APPENDIX B:
CONCECPTUAL CORRIDORS AND STAKEHOLDER'S MEETING #2
PURPOSE AND NEED DOCUMENT
ENVIRONMENTAL OVERVIEW
DESIGN CRITERIA AND TYPICAL SECTIONS

Devola Multi-Use Trail

Meeting Minutes

Re: Devola Multi-Use Trail Stakeholder Meeting #2

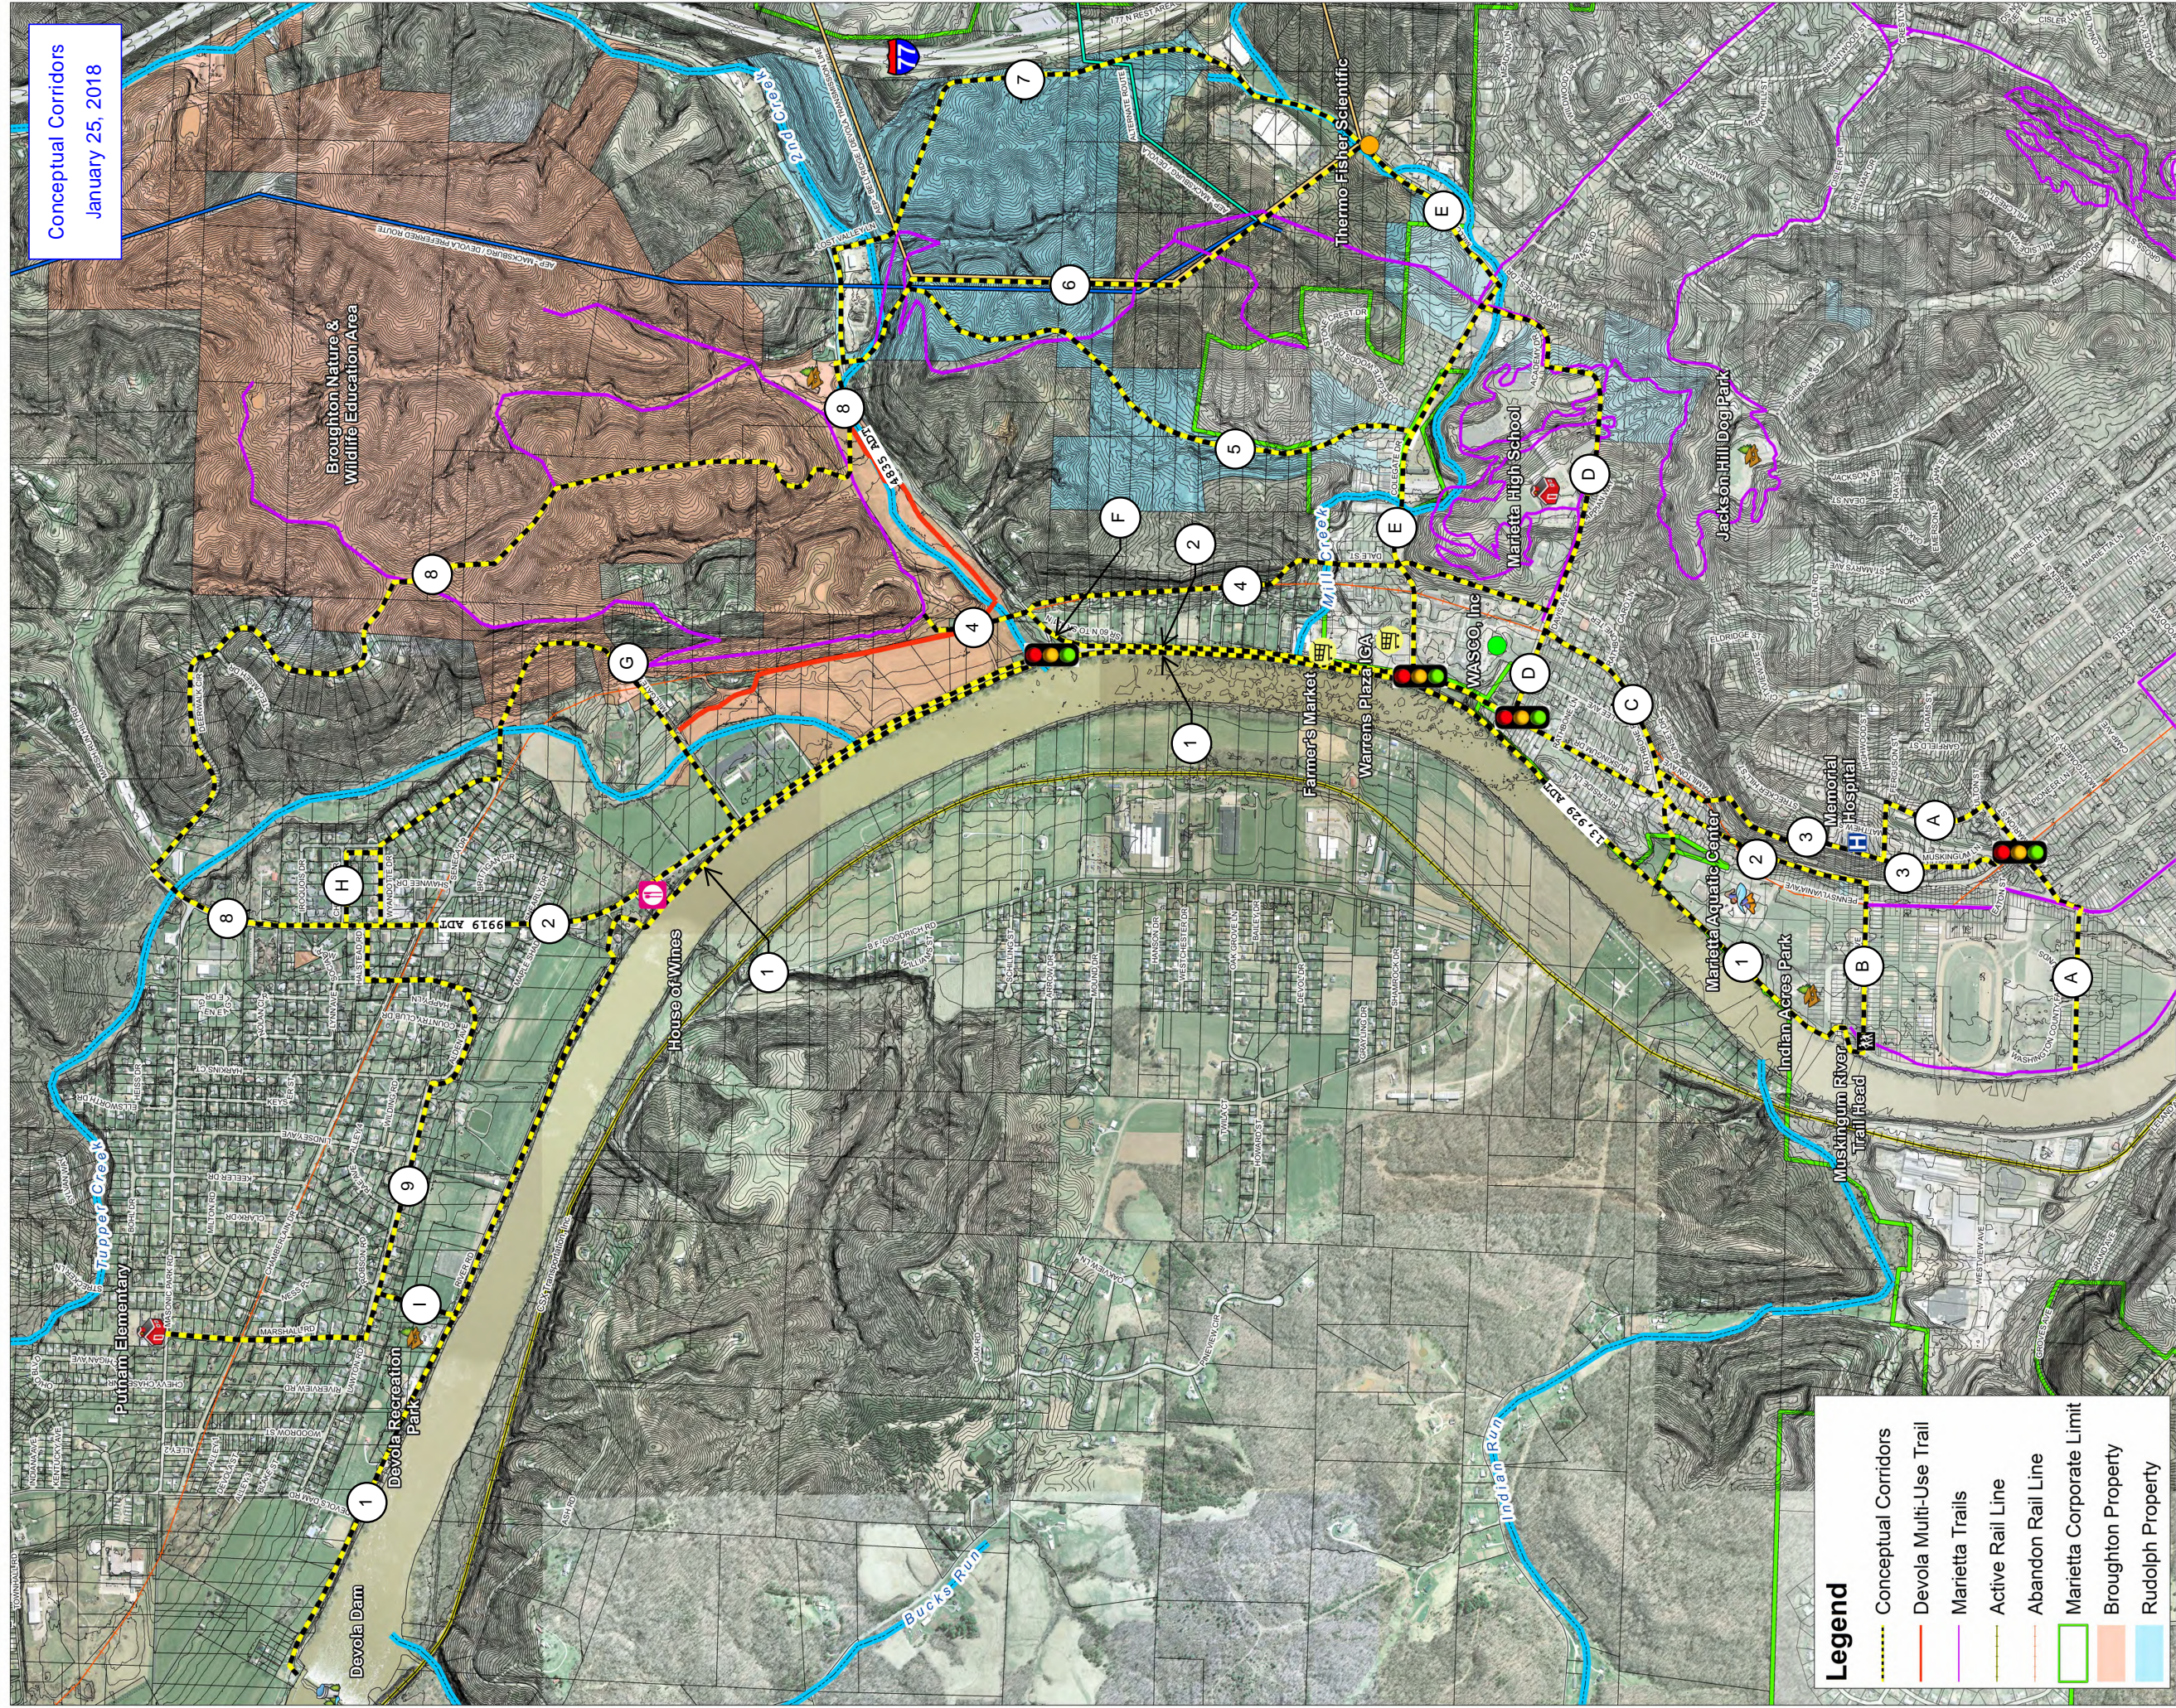
1. The corridor exhibit is numbers so the north /south routes are labeled with a number, and east / west routes are labeled with a letter. This format will facilitate the discussion regarding alternatives.

2. The City noted the corporation limits north of the Marietta Aquatic Center appear to be incorrect. The Shrine has recently been incorporated, and City officials will investigate updating the GIS information.

16. Stakeholders noted the Marietta School Board has considered the Rudolph Property on SR-821 as a potential site for a new high school.
17. Tracy Brown noted that Corridors 6 and 7 are far away from the communities, and might not need the purpose and need of the project. There was also discussion regarding the feel of the trail in this area, and it was suggested that photos of similar trails be presented.

18. Travelling between Marietta and Devola along Corridor 7 and 8 would be difficult for some trail users. Corridor 7 was chosen because there is an old road that was abandoned after I-77 was constructed. The roadbed has the potential to provide adequate grades through rough terrain. Eric Lambert asked if the length of each corridor was known, which would help facilitate stakeholder decisions. Lengths are not known at this time.

24. The City of Marietta felt Corridor 3 is better than Corridor A due to available roadway width. City officials also noted the Hospital is buying properties in the area and they have created a green space. The corridors should be presented to the Hospital. Woolpert has discussed the potential trail with Hospital representatives.

25. It was noted that Corridor E goes through an industrial area and would not be considered a scenic trail.
26. Corridor 4 follows the old inner-urban rail line. Further research is required on the location of this rail line to determine where it was located, and if the property has reverted to the original owners.

27. Longer corridors, such as Corridors 7 and 8 could be presented as future trails to be completed afterwards. Corridor B could be rerouted onto Pennsylvania Avenue to avoid this portion of Muskingum Drive, which is very tight. The City would like to avoid Muskingum Avenue if possible due to the limited width available.

1. Update the exhibit to include nodes at each intersection for distribution.
2. Obtain photos of other multi-use trails to present to the public.
3. Measure the distance of the corridors and distribute to stakeholders.
4. Distribute updated mapping and information to Stakeholders.
